AGENDA FOR REGULAR MEETING VILLAGE OF TINLEY PARK PLAN COMMISSION

PLAN COMMISSION STAFF REPORT

THE BOULEVARD AT CENTRAL STATION

6701-6755 South Street

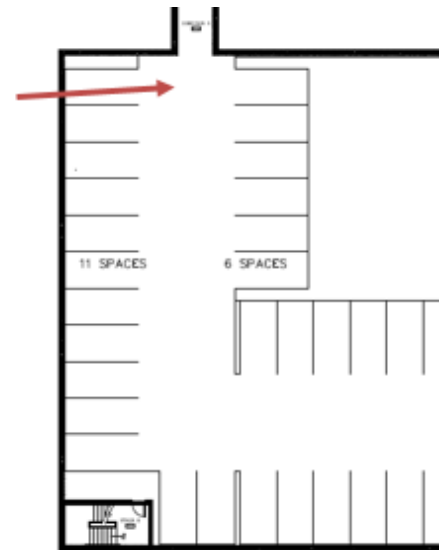
Staff has expressed concern over the design of the lower level floor of the parking garage. The image to the right does not provide the ability for a vehicle to turn around. A vehicle would have to back out approximately 90-100' to exit the area. The plans should be revised to eliminate two (2) stalls or to convert these spaces for motorcycle parking.

New Open Item #6: The Site Plan approval plans should be revised to address staff's concern regarding the inability to easily exit the lower level floor parking area.

6. Lower Level Parking Turnaround	Staff recommends a condition of the Site Plan approval to revise the plans to allow for a vehicle to turnaround

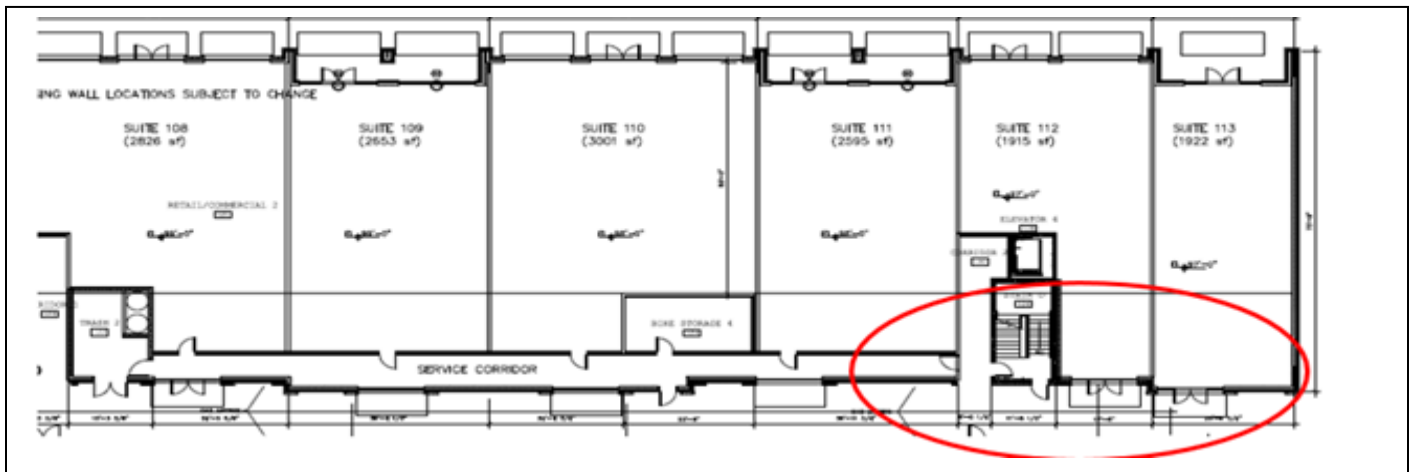
On each floor, there is a recycling room at the far east end of each building. Staff has requested the architects to have this area centralized with the trash room. The bricked in window for the recycling room can then be converted into a glass window to bring natural light to the end of the hallways.

Open Item #15: The architect should look at consolidating the recycling rooms into the main trash area. The architect has eliminated the recycling rooms at the end of the hallway for each floor.

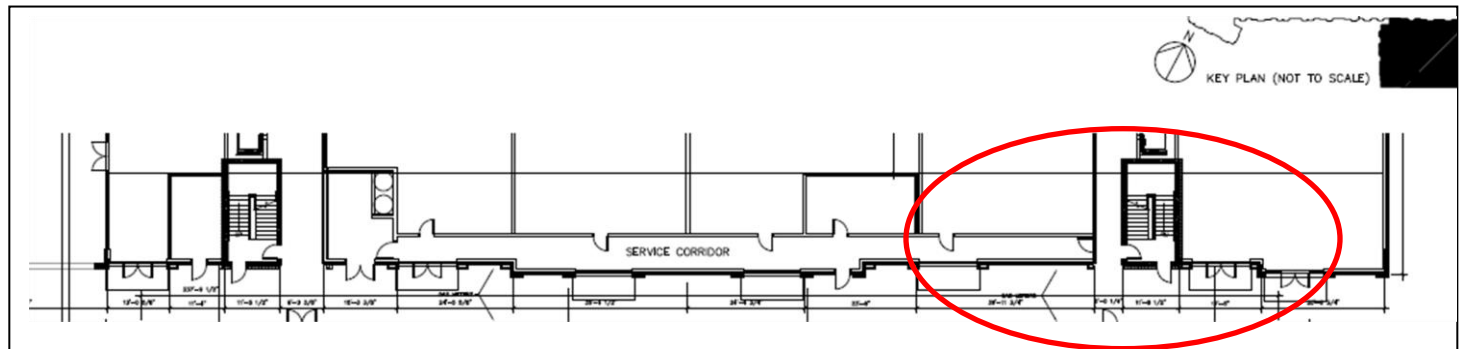
Open Item #17: Staff questions the need for the internal service corridor proposed in Phase 2. Staff recommends further discussion on the issue regarding the integration of the parking deck and commercial units instead of spacing them and creating an open walkway.

17. Staff questions the need for the internal service corridor proposed in Phase 2.	Further discussion needed.
18. Provide for a unified sign plan.	Submitted.

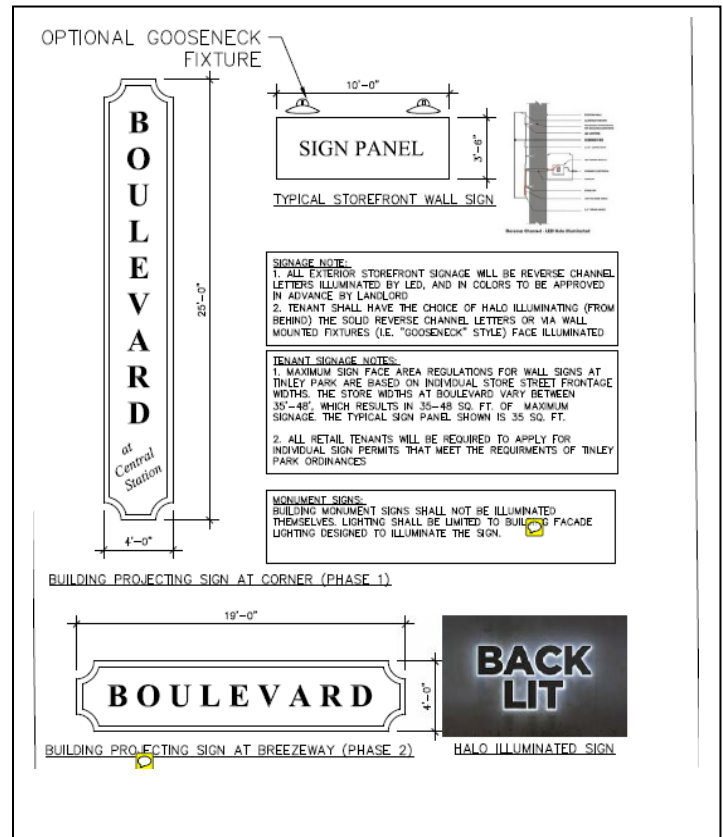
by the Landlord. As with other large projects of this size Staff recommends the Applicant provide a Unified Sign Plan that will regulated the size, color, illumination, style and material of the wall signs for this project. **The architect has provided a unified sign plan which gives the tenant the choice of Halo illuminating (from behind) solid reverse channel letters or via wall mounted fixtures (“gooseneck” style). There is reference to monument electronic reader and freestanding signs that need to be removed because the site physically cannot provide areas for these signs to be placed on the property and meet all the Code requirements.** Although not required, Staff also recommends the Applicant limit the signs to one color and allow for individual font and style that can provide for individual branding. It is Staff's preference that these signs be externally illuminating which is consistent with a downtown urban character. Staff also strongly encourages the use of projecting or blade signs, which are typical in pedestrian oriented developments such as this. **Projection signs and the material allowed should be included in the Unified Sign Plan.** The goal is to have a sign plan that can complement the overall architecture of the entire building that addresses the pedestrian orientation of this district.

Open Item #19: Provide for a unified sign plan. The Unified Sign plan needs to be revised to exclude any reference to free standing or monument electronic reader signs. A section should be included to allow projection signs and require a standard material to be used (I.E. wood or metal). It is recommended that the same material be used for all projections signs.

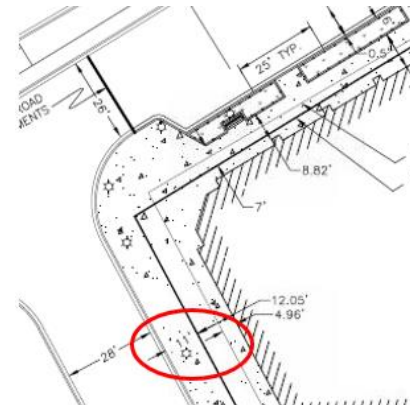
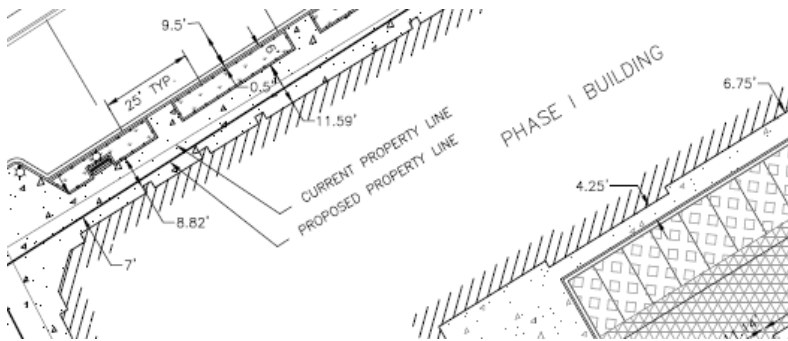
The Plat proposed dedicating right-of-way to the Village along the frontage of Phase 1. This was requested in order to accommodate a minimum seven (7) foot wide public sidewalk. The area along 67th Court only provides for a total of 11 feet of public right-of-way where code requires a minimum of 13 feet. This item needs to be verified with the engineering department that an eleven (11) foot public right-of-way is adequate instead of the required 13. The goal is to provide enough room for the necessary street improvements and provide enough space for outdoor dining. **The Village's consulting engineer has determined the R.O.W. width along 67th Court can be reduced from 28' to 26' which would give the Village the necessary 13 feet for future streetscape and sidewalk. This will all be determined during final engineering and will be a condition of Final Plat Approval.**

Open Item #26: Further discuss with the engineer regarding the required right of way along 67th Court should be 11' vs. 13'. **This has been resolved.**

LT100
SITE LIGHTING CALC.

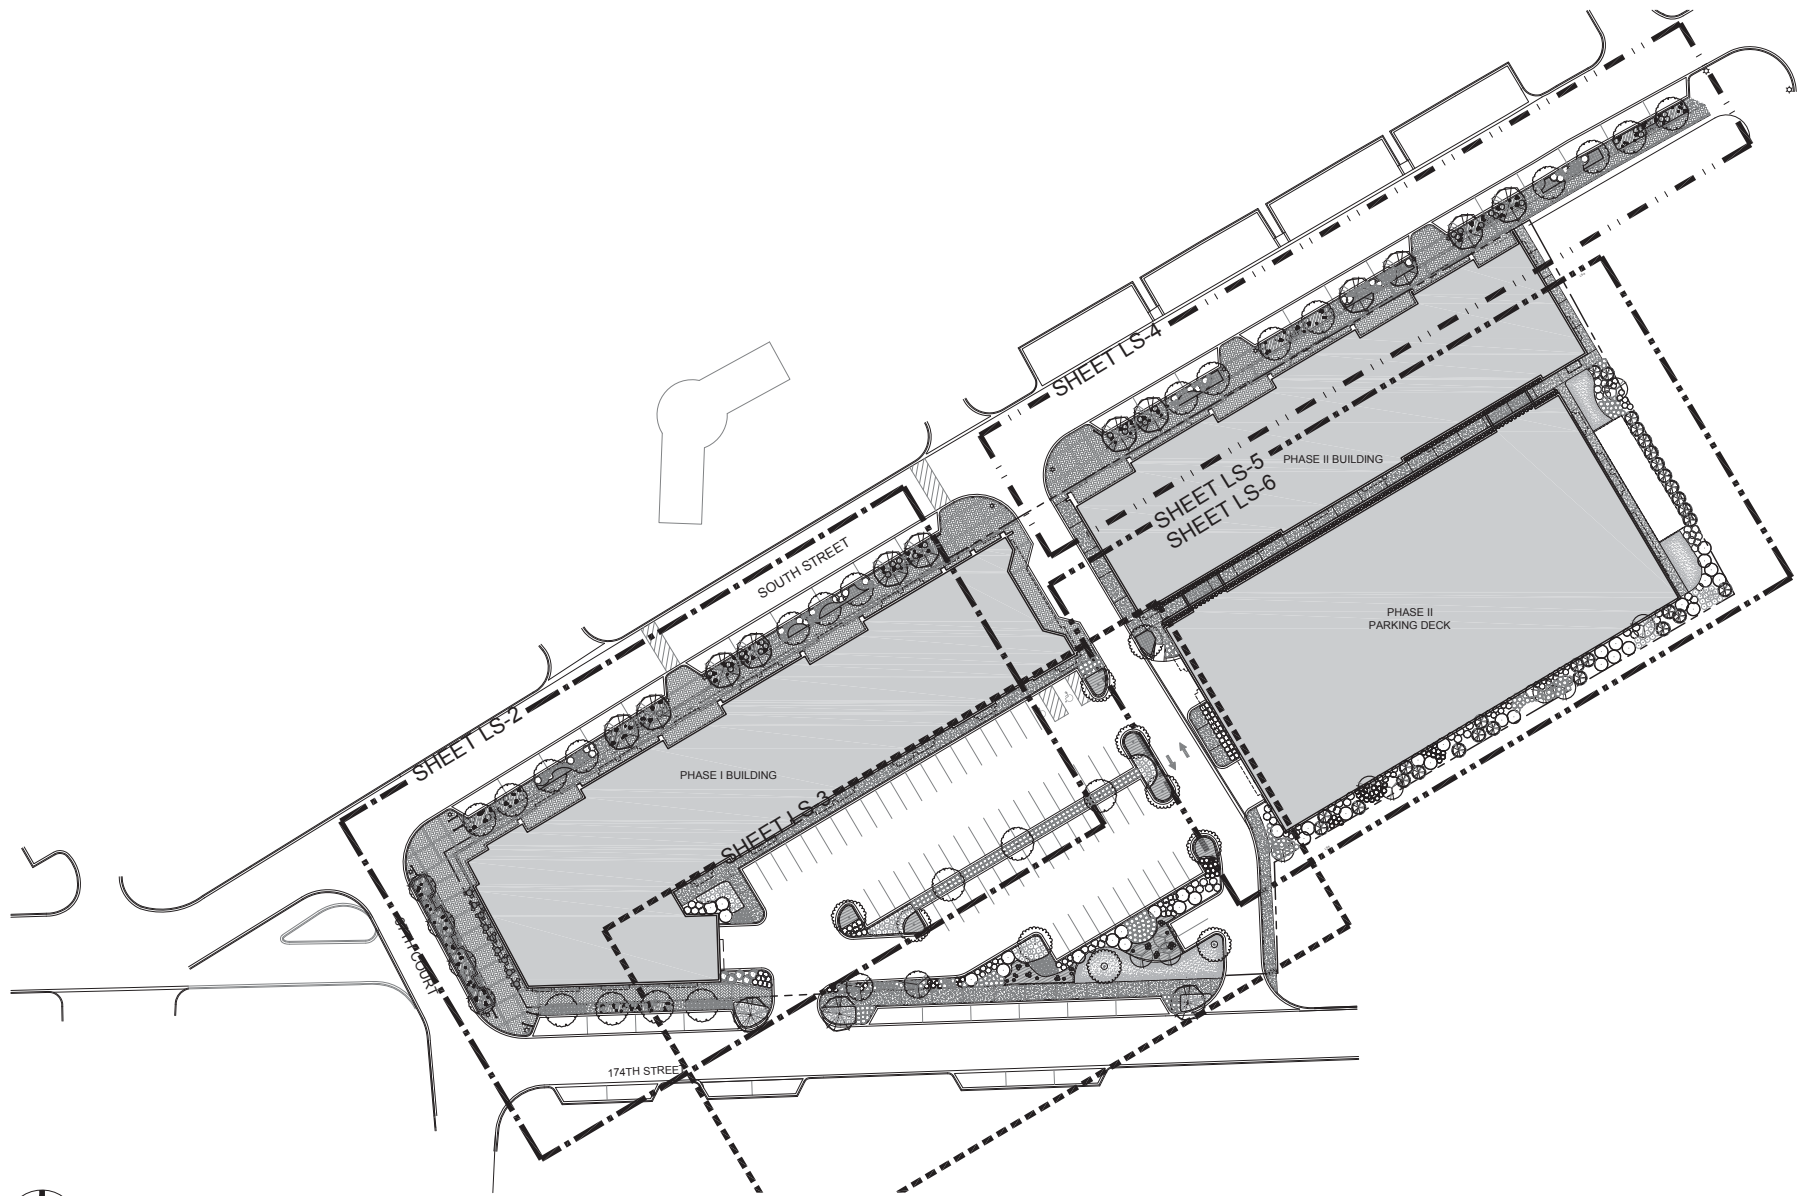
A photometric plan has been submitted (Sheet LT100). The plans are still conceptual and a final photometric plan with cut sheets of the fixtures will need to be submitted prior to final approval. It has been noted by our engineers that the plan does not provide for any parking lot lights in the surface parking lot in Phase 1.

Open Item #21: A final photometric plan will need to be provided with final engineering. Staff recommends the Site Plan be conditioned upon final approval of the photometric plan, which includes lighting in the surface parking lot in Phase 1.

19. Staff recommends that the main identification signs for the building not be illuminated.	Resolved.
20. Photometric plan will need to be provided with final engineering.	Staff recommends the Site Plan be conditioned upon final approval of the photometric plan, which includes lighting in the surface parking lot in Phase 1.
